Low Carbon Construction Voting Guide

ICC 2022 Online Governmental Consensus Voting

Group B Code Development Cycle

FIGURE R403.5(1) CRUSHED STONE FOOTINGS FOR CAST-IN-PLACE FOUNDATIONS IN SEISMIC DESIGN CATEGORIES A, B, AND C - MASONRY OR CAST-IN-PLACE CONCRETE FOUNDATION WALL

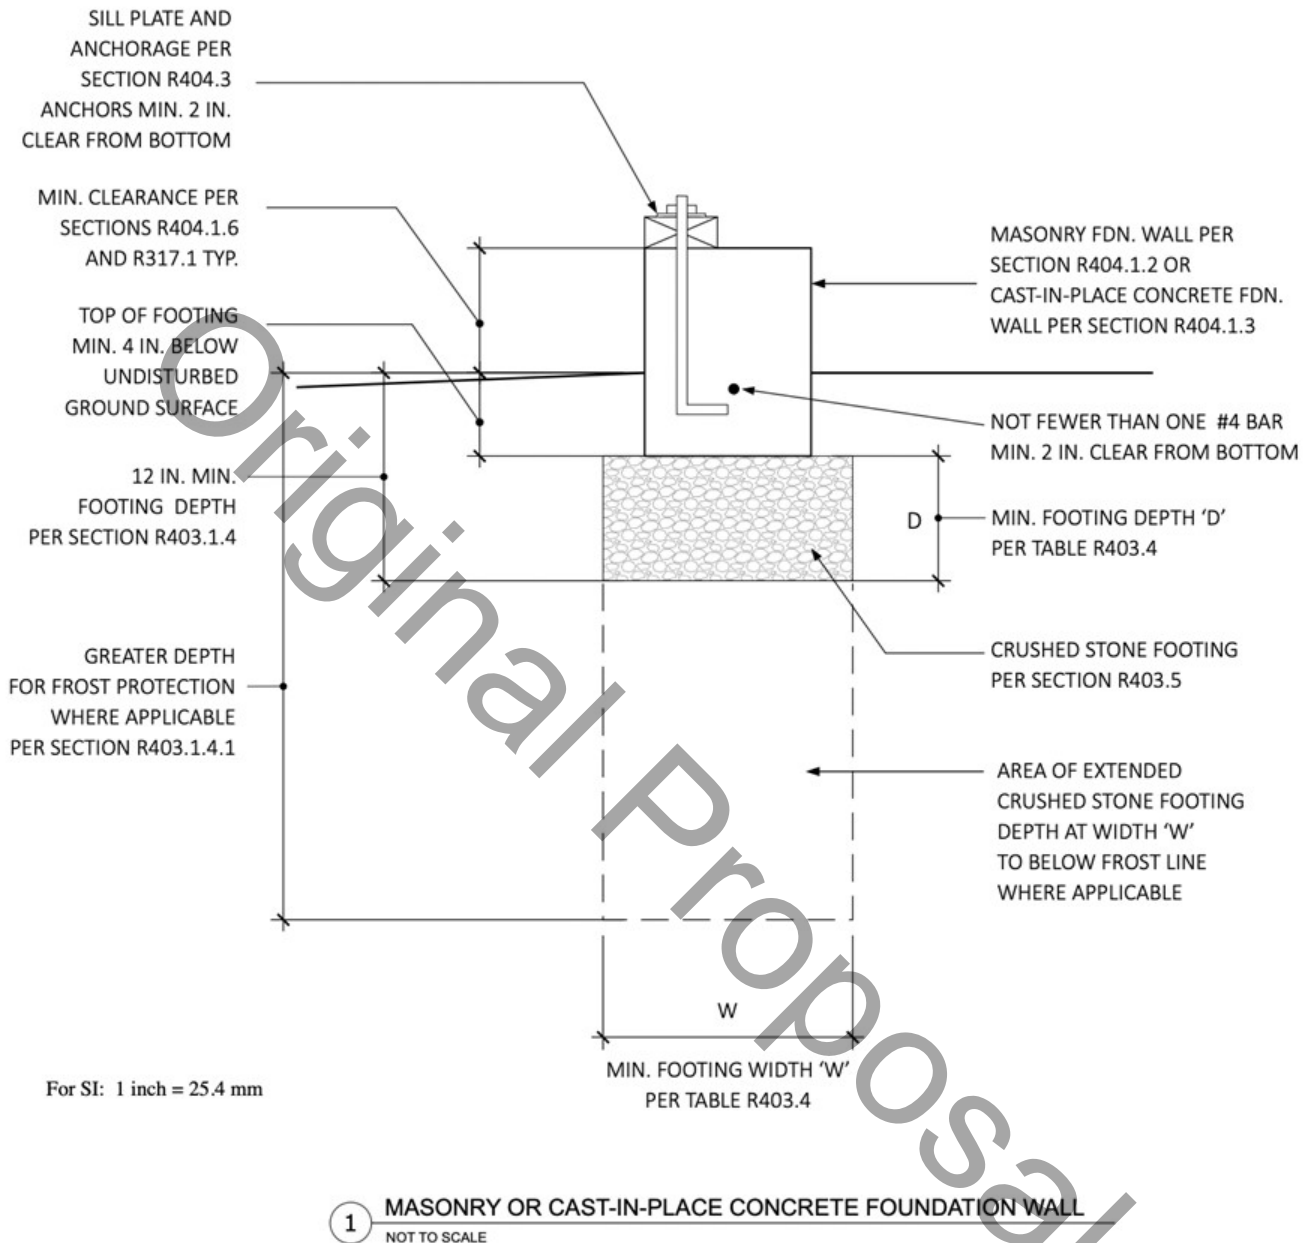
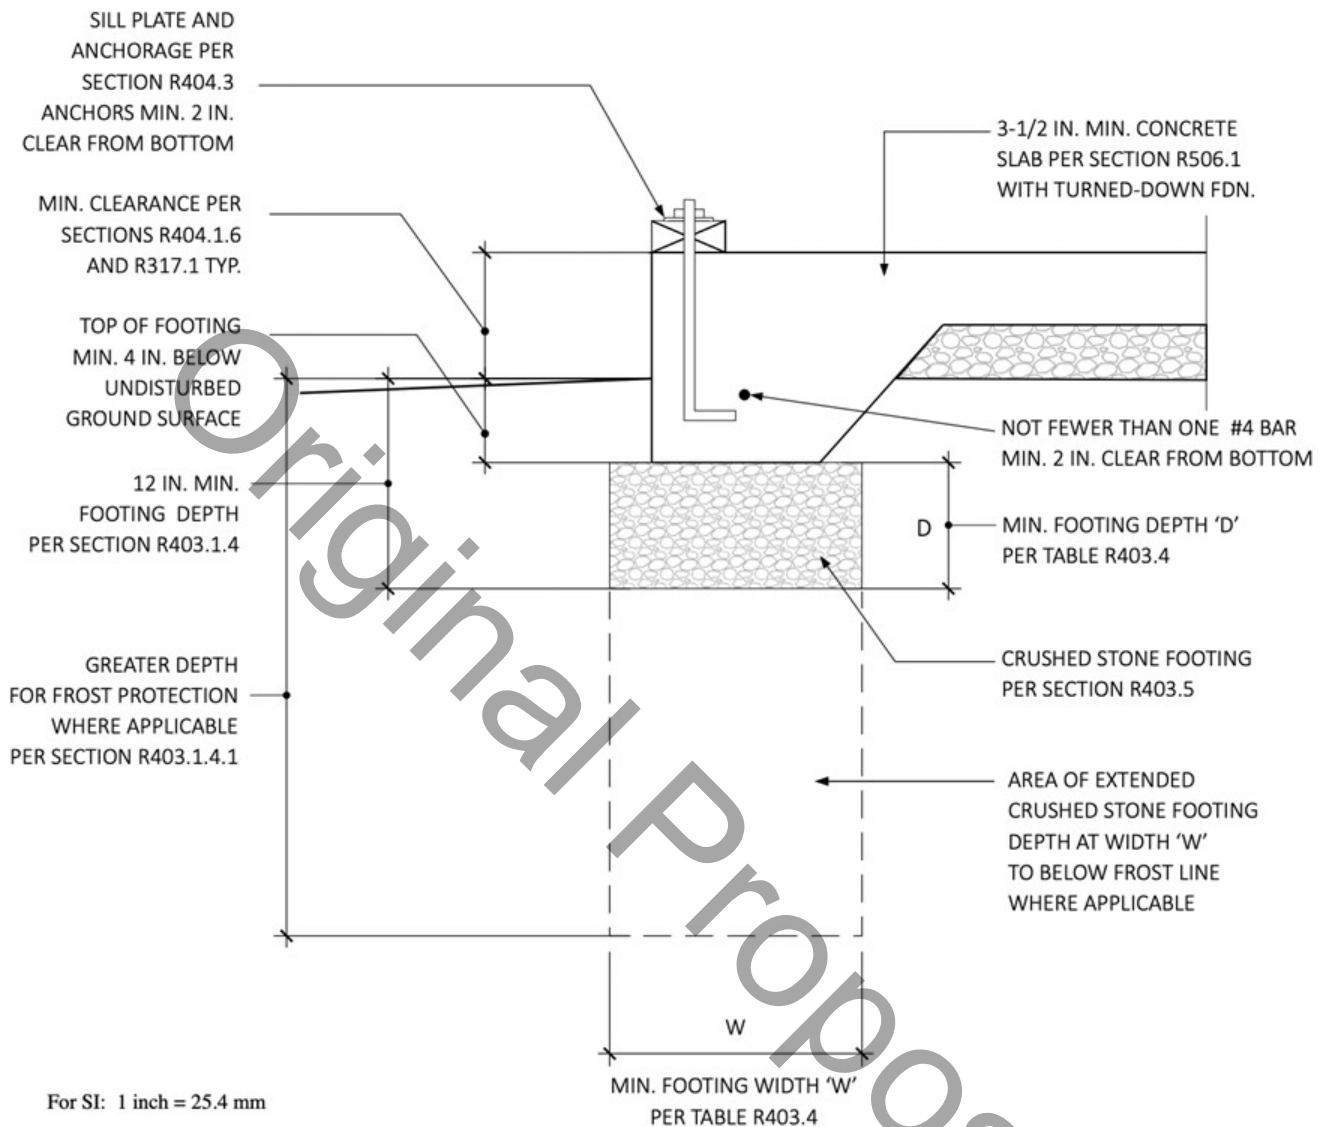
R403.5 Crushed stone footings for cast-in-place foundations. Crushed stone footings for masonry or cast-in-place concrete foundations complying with Section R404.1 shall comply with Section R403.4.1 except they shall be installed in accordance with Figures R403.5(1) or R403.5(2).

Reason: Crushed stone footings for wood foundations and precast concrete foundations are currently permitted in IRC Sections R403.2 and R403.4.1 respectively. There is also the well-established geotechnical practice of using crushed stone underlayment for foundations of all types. This proposal simply allows these provisions to also be used for masonry foundations and cast-in-place concrete foundations.

This proposal uses identical requirements for crushed stone and its placement as those for analogous pre-cast concrete foundations in Section R403.4.1 (by reference), and for footing width and depth in the associated Table R403.4. The proposal limits the proposed use of crushed stone to Seismic Design Categories A, B, and C, by reference as stated in Section R403.4.1. New Figures R403.5(1) and (2) illustrate the requirements, including minimums regarding the top of the footing relative to undisturbed ground surface. The Figures illustrate two conditions for crushed stone footings: 1) masonry or concrete wall foundation, and 2) slab-on-ground with turned down foundation. Conservatively, not less than one #4 bar is required for these foundations over a crushed stone footing. This is not currently required for plain concrete footings or turned-down footings in Seismic Design Categories A, B, and C. Minimum clearances for the #4 bar and the sill plate anchor are also stated in the Figures.

FIGURE R403.5(1) CRUSHED STONE FOOTINGS FOR CAST-IN-PLACE CONCRETE FOUNDATIONS IN SEISMIC DESIGN CATEGORIES A, B, AND C AND WIND EXPOSURE CATEGORIES B, C, AND D - CAST-IN-PLACE CONCRETE FOUNDATION WALL WITH WOOD CRIPPLE WALL

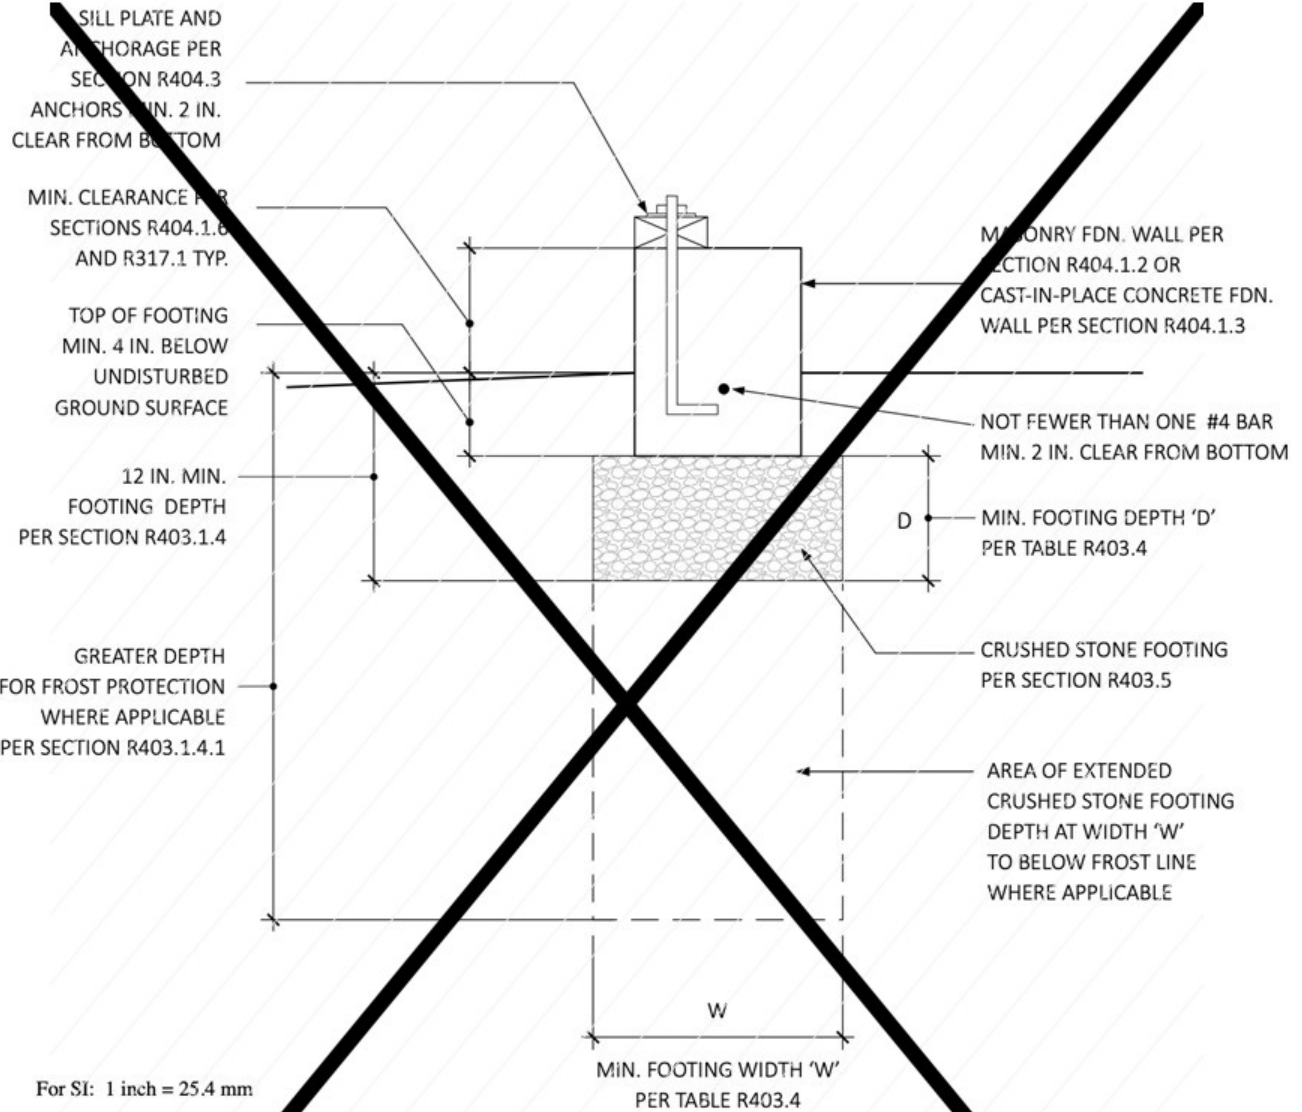
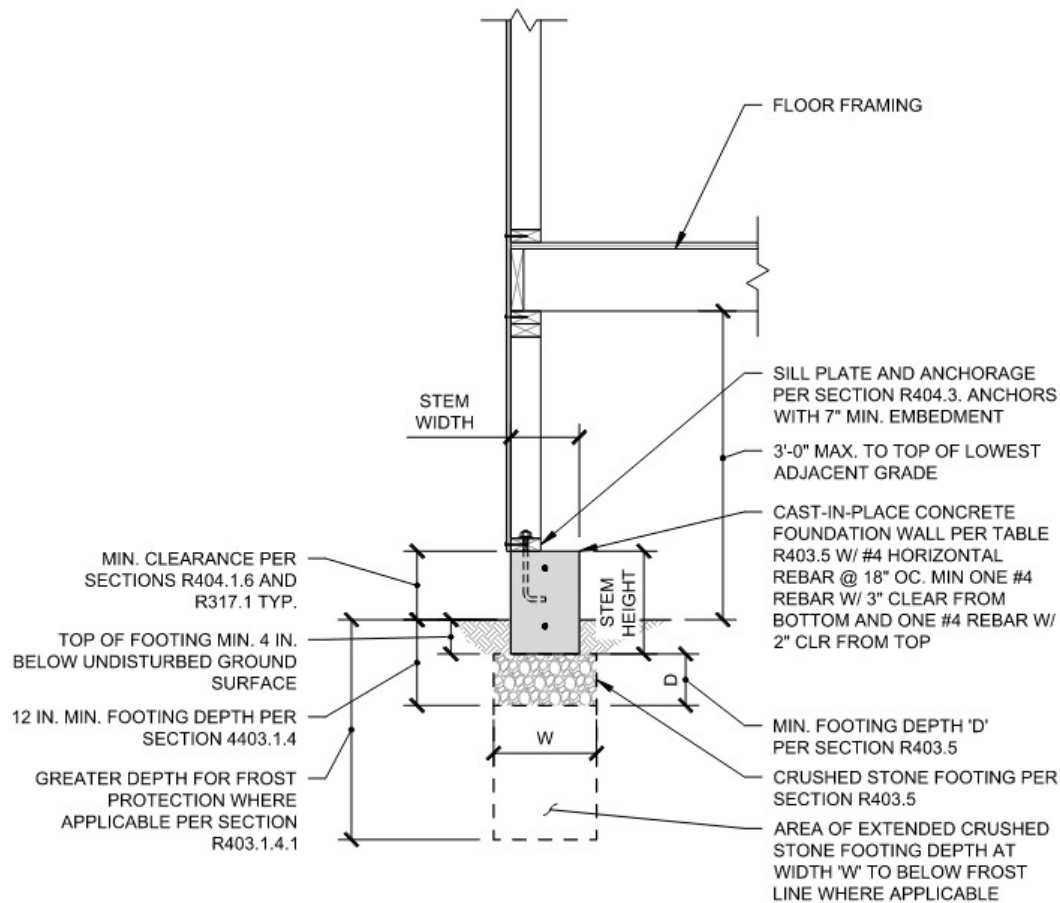
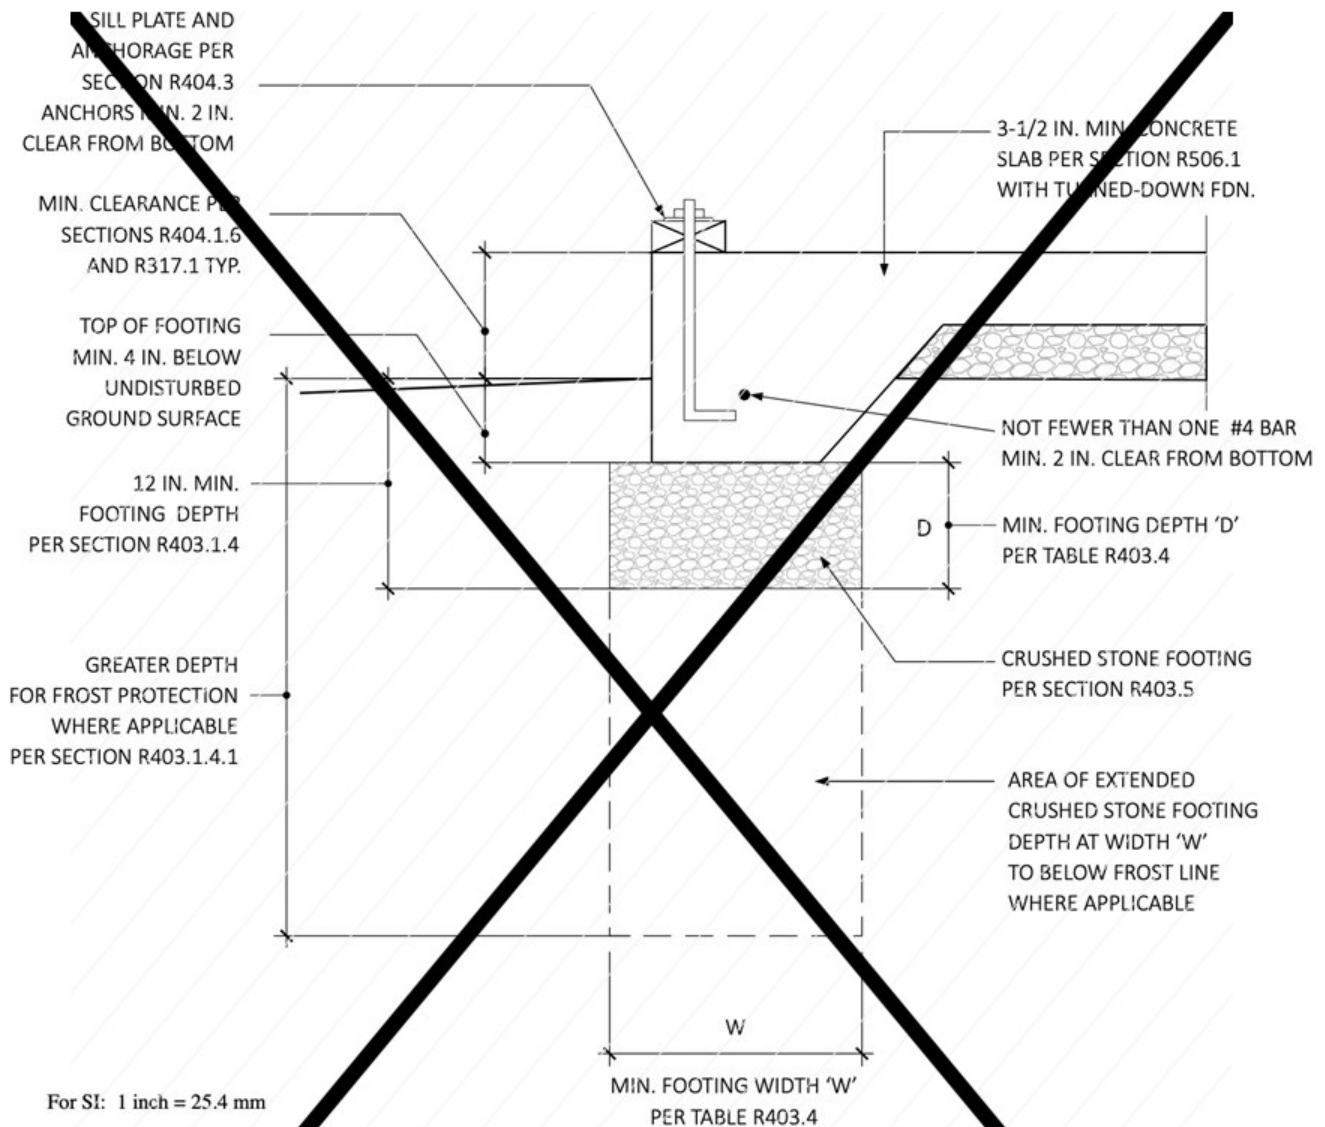
1. New or revised Figures R403.5(1), (2), and (3) illustrate the requirements of these provisions, referencing applicable section numbers. The Figures illustrate three conditions: (1) concrete foundation wall with a cripple wall (added with this Public Comment), (2) concrete foundation wall with no cripple wall, and (3) concrete slab-on-ground with turned-down foundation.

R403.5 Crushed stone footings for cast-in-place concrete foundations. Crushed stone footings ~~for masonry or cast-in-place concrete foundations complying in accordance with Section R403.4.1 shall comply~~ shall be permitted for non-retaining cast-in-place concrete foundations complying with Section R404.1 R404.1.3 and this section except they. The footing and foundation wall shall be installed in accordance with Figures R403.5(1); or Figure R403.5(2) and Table R403.5, or Figure R403.5(3). Crushed stone footings for cast-in-place concrete foundations shall be permitted for townhouses in Seismic Design Categories A and B and one- and two-family dwellings in Seismic Design Categories A, B and C.
